Subject: Bisnow Residence – Follow-up Review Comments

## Plan Review Comments – No. 2

**Project Name:** Bisnow Residence

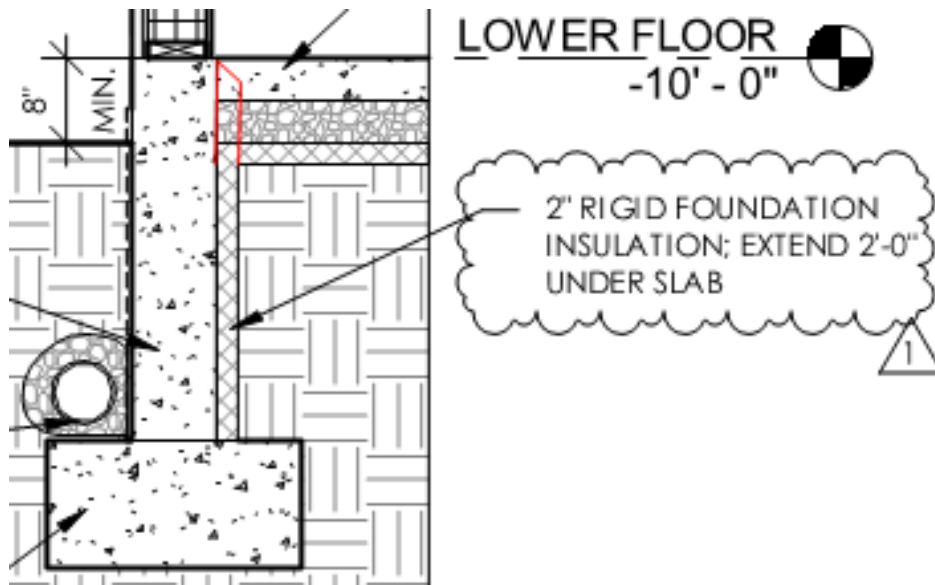
A8. From the wall sections it appears that there are areas of the home with a slab on grade when the slab is not at least 12 inches below grade. This would require that the slab be insulated according to IRC N1102.2.9. Please address.

**PC2:** *The revision provided shows insulation under the slab and on the inside of the foundation wall but according to IRC N1102.2.9 this insulation must extend to the top of the slab. Below is attached the revised detail with red lines showing a proposed way to insulate that is described in this section of the code.*
